MAINE TURNPIKE AUTHORITY

ADDENDUM NO. 1

CONTRACT 2019.04

INTERCHANGE 103 BARRIER TOLL PLAZA
OPEN ROAD TOLLING CONVERSION
MILE 103.00

CONTRACT: 2019.04
SHEET NUMBER: SF-01
205A OF 503

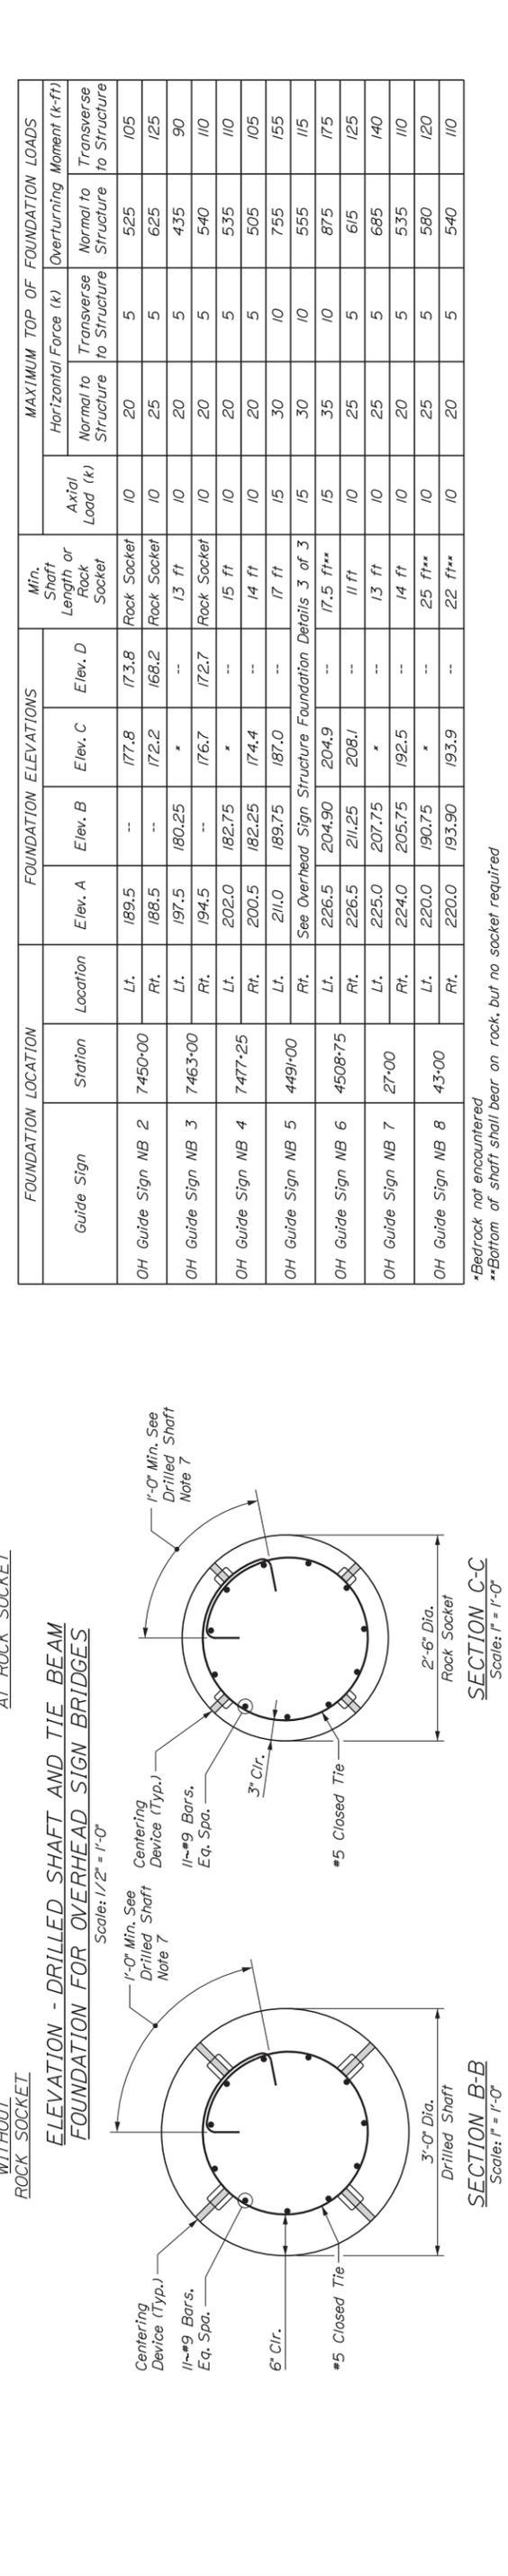
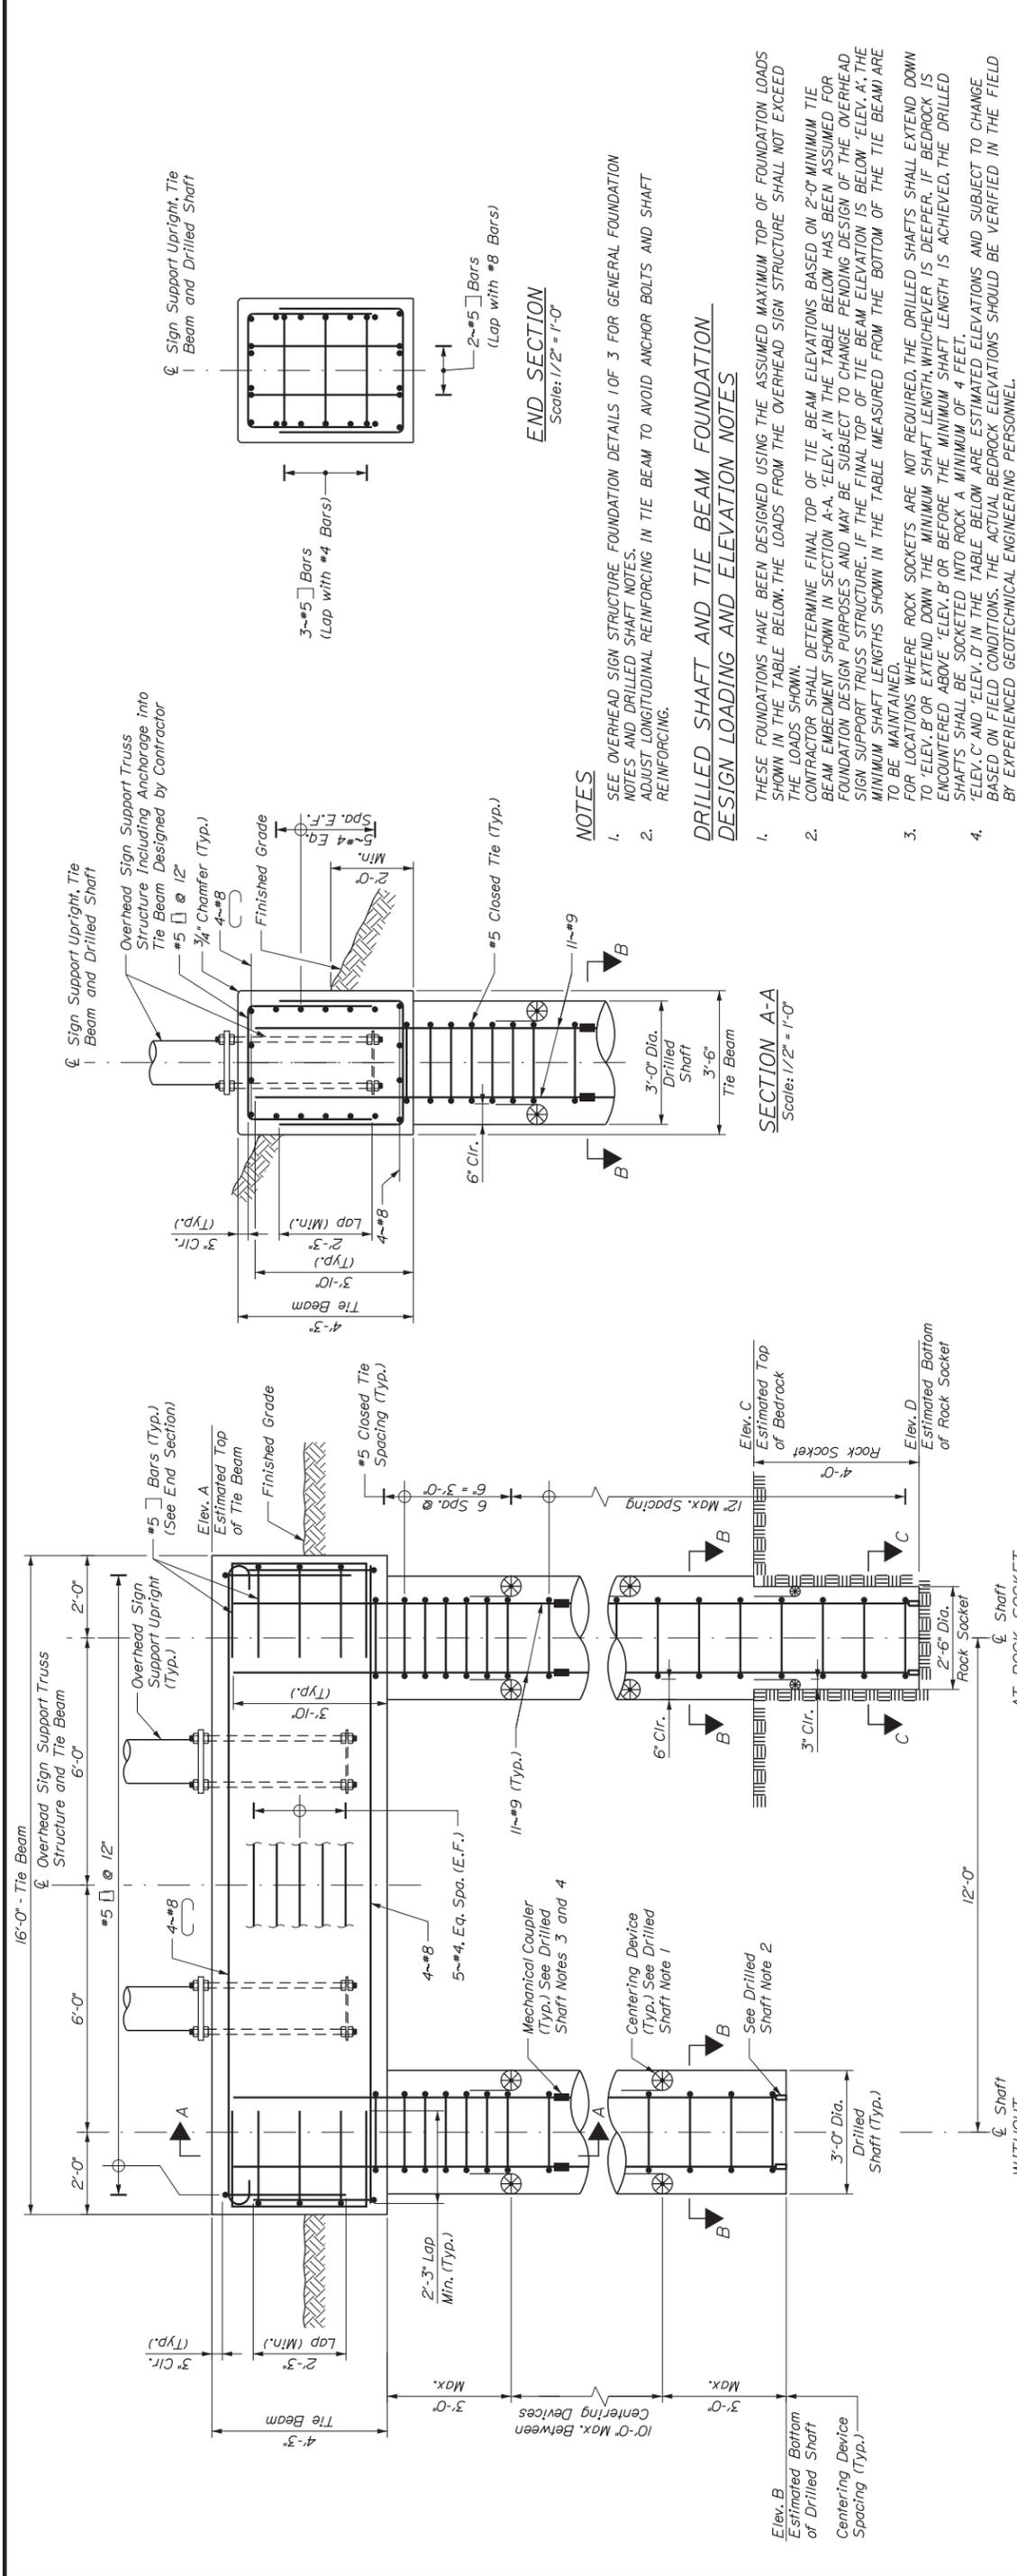
- Plan Sheets 205A, OVERHEAD SIGN STRUCTURE FOUNDATION DETAILS 1 OF 3, 205B, OVERHEAD SIGN STRUCTURE FOUNDATION DETAILS 2 OF 3 and 205C, OVERHEAD SIGN STRUCTURE FOUNDATION DETAILS 3 OF 3 are added to the set after Sheet 205.

Answer: Yes, plans and Special Provision 645 are include in this addendum.

No.	Revision	By	Date
1	ADDENDUM 1 - ADDED SHEET	DDT	4/19

SHEET NUMBER: XS-121
 355 OF 503

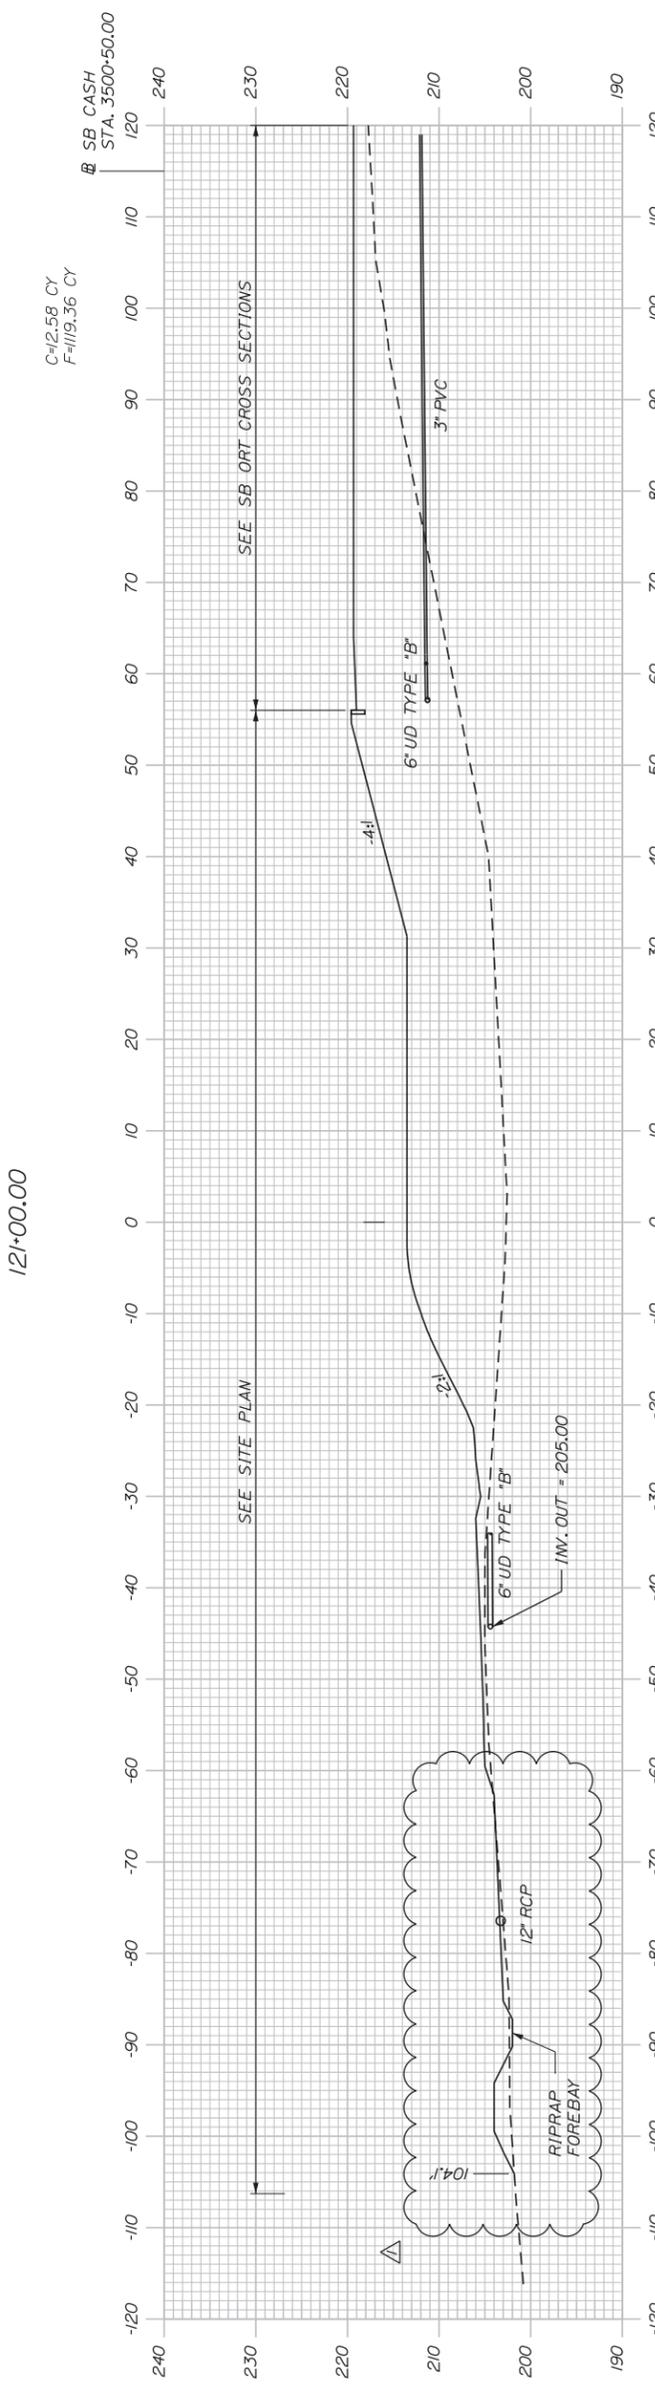
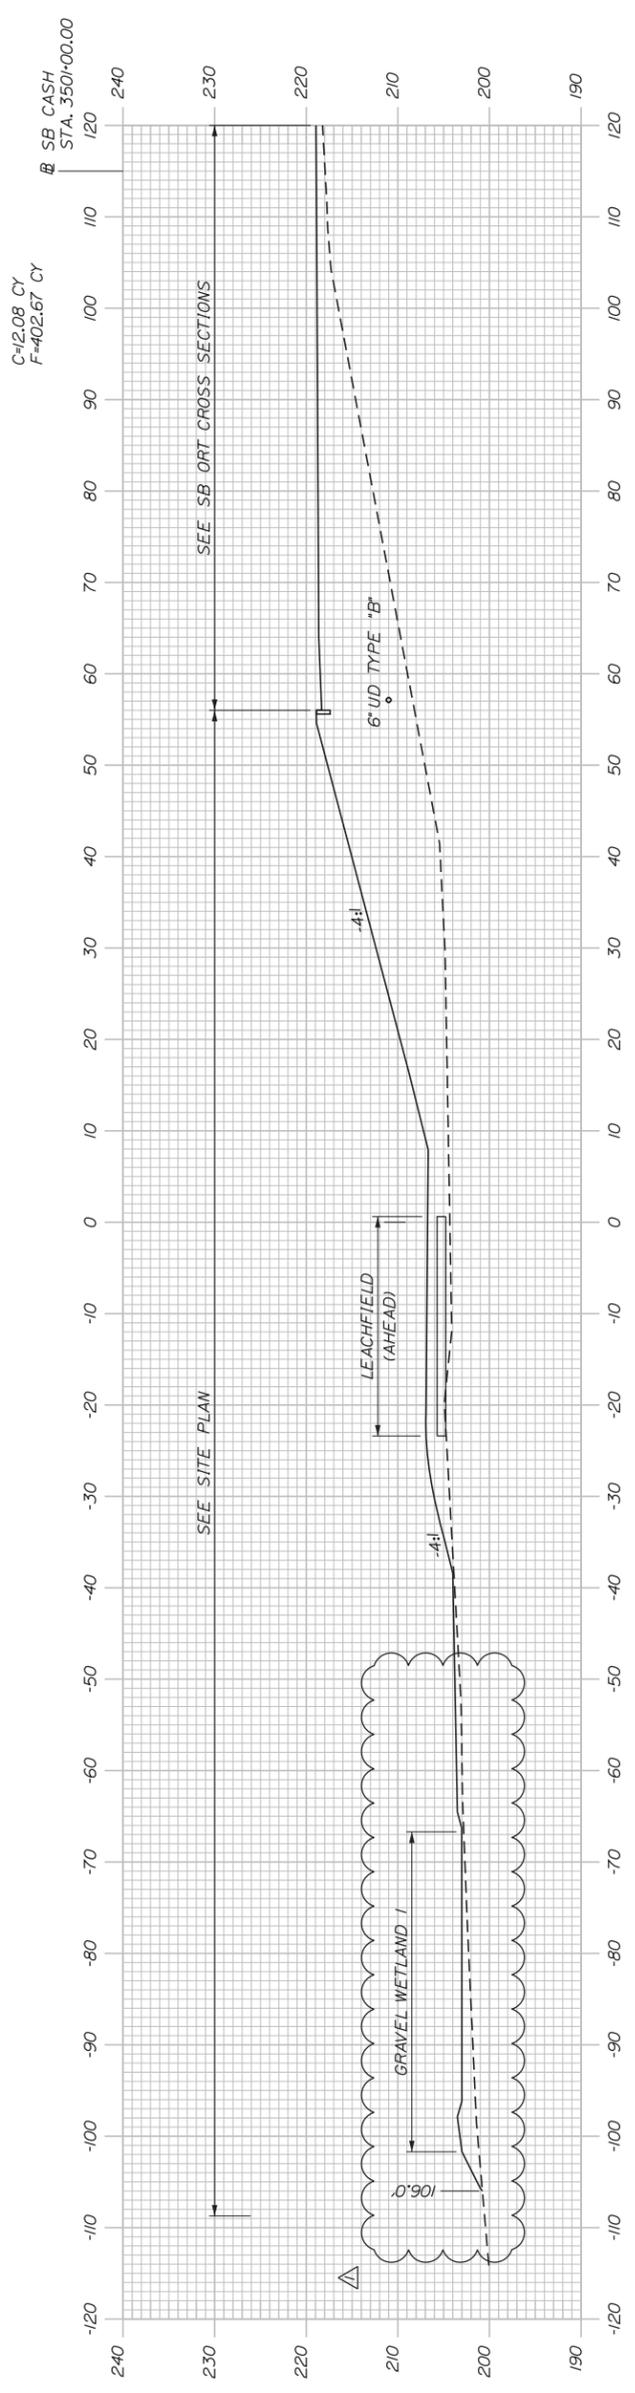
- Plan Sheets 354, 355 and 358 of 503, ACCESS ROAD STA. 114+00.00 TO 116+50.00, ACCESS ROAD STA. 117+00.00 TO 118+00.00, and ACCESS ROAD STA. 120+50.00 TO 121+00.00, have been deleted in their entirety and replaced with Plan Sheets 354, 355 and 358 of 503.

No.	Revision	By	Date
1	REVISIONS TO GRAVEL WETLAND	TFD	4/19
